Access Compliance Report

Public Rights-of-Way

(Curb Ramps)

Intersection ID: 49291	Main Street: ARDREY_CREST_DR	Cross Street: CHAMBERLIN_RD	Location: SE
ADA ID: CCF2A79CECA8	Ramp Type: PerpDiag	Initial Pass/Fail: Fail	Overall Compliance: No
Severity Score: 12.5			
Codes/Mitigation Info/Possible Solution		Field Measurements/Component Compliance

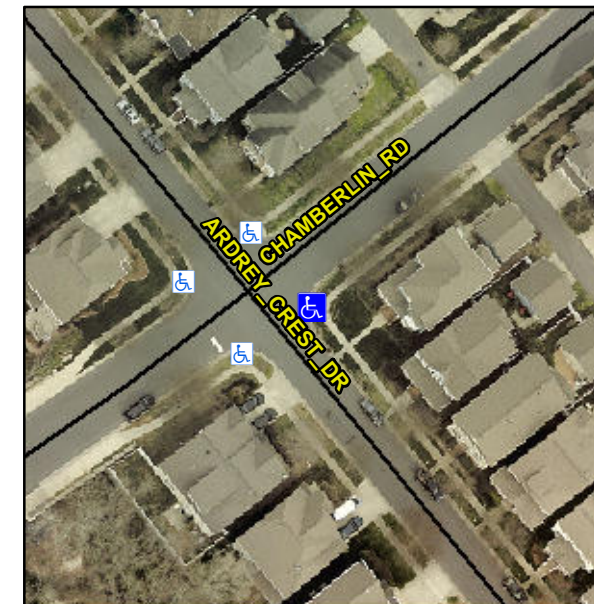
Not Found, R304.2.2

Compliance	Description	Data	Compliance	Description	Data
N/A	Ramp Length (in)	70.0	No	Ramp Slope (%)	8.6
Yes	Ramp Width (in)	48.0	Yes	Ramp XSlope (%)	0.7
N/A	Flare Type LT	N/A	N/A	Flare Type RT	N/A
N/A	Flare Slope LT (%)	N/A	N/A	Flare Slope RT (%)	N/A
N/A	Flare Traversable LT?	N/A	N/A	Flare Traversable RT?	N/A
N/A	Landing Length (in)	N/A	N/A	DWS Provided?	N/A
N/A	Landing Width (in)	N/A	N/A	DWS Contrast?	N/A
N/A	Landing Slope (%)	N/A	N/A	DWS Length (in)	N/A
N/A	Landing X Slope (%)	N/A	N/A	DWS Full Width?	N/A
N/A	Landing Curb? (Y/N)	N/A	N/A	DWS Offset (in)	N/A
N/A	Shared Landing?	N/A			
N/A	Gutter Ponding?	N/A	N/A	Gutter Slope (%)	N/A
N/A	Gutter Lip Ht (in)	N/A	N/A	Gutter X Slope (%)	N/A
N/A	Painted X Walk1?	No	N/A	Painted X Walk2?	No
	X Walk 1 Direction	To NW		X Walk 2 Direction	To SW
N/A	X Walk 1 Width (in)	N/A	N/A	X Walk 2 Width (in)	N/A
	X Walk 1 Slope (%)	2.6		X Walk 2 Slope (%)	3.8
	X Walk 1 X Slope (%)	2.1		X Walk 2 X Slope (%)	2.0

Remove & Replace Curb Ramp With Two New Directional Ramps or Equivalent.
